Project: Alba Potline (6) and Power Plant (PS 5) Expansion

Addendum to Environmental and Social Impact Assessment Report

Document number: 3311003

Revision: E

Figure 1: Design Changes in Power Station 5

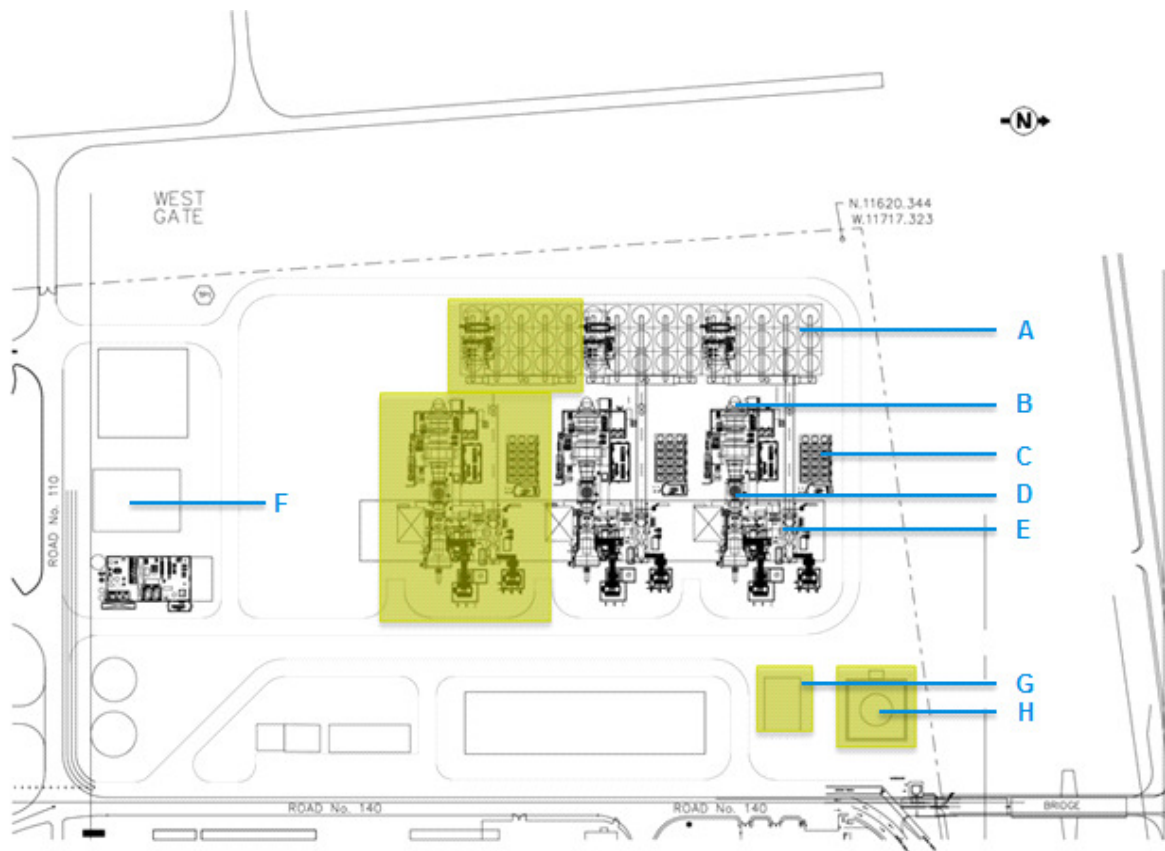
The initial design of PS 5, for which the ESIA was prepared, comprised two (2) F class units. In the current design change, an extra F class unit is added to the power station, hereafter referred to as PS-5C. Furthermore, the existing PS-2 will be shut-down and additional power² will no longer be sourced from the Electricity and Water Authority (EWA) grid.

- Additional F class unit for Power Station 5;
- Increased capacity of water storage tanks; and

The above listed design changes are illustrated in **Figure 1**.

To provide a black start, diesel generators with a capacity of 18 to 22 MW will be used. These generators require the installation of a diesel storage tank (see **Figure 1**) with a storage capacity of 140 cubic metres (m³), sufficient for one day operation.
